MODEL 203.0 /2, 208.3, 210, 215, 220
with CODE (412) Electric tilting/sliding roof
with CODE (414) Glass electric tilting/sliding roof
MODEL 209.3, 211 with CODE (414) Glass electric tilting/sliding roof
MODEL 240 with CODE (414) Glass electric tilting/sliding roof

Modification notes

Shown on model 211

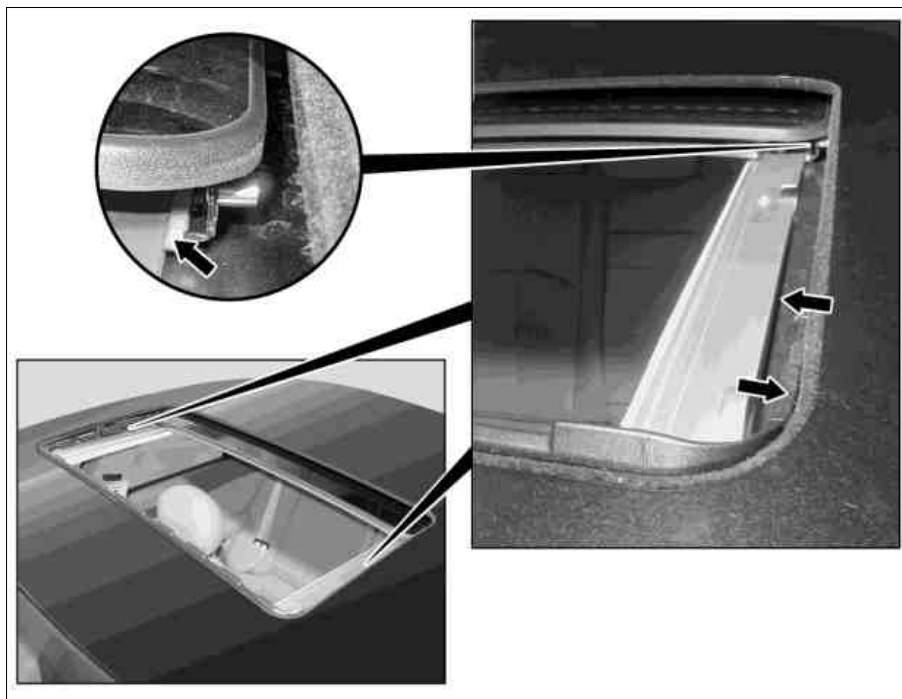
11.7.02	"Coat slide rails and slide blocks with grease" newly included.	Step 3	
---------	---	--------	--

Cleaning		
1	Completely open tilting/sliding roof		
2	Clean slide rails and slide blocks (arrows).		
3	Coat slide rails and slide blocks (arrows) thinly with grease		*BR00.45-Z-1046-06A
4	Check tilting/sliding roof for proper function		
5	Close tilting/sliding roof
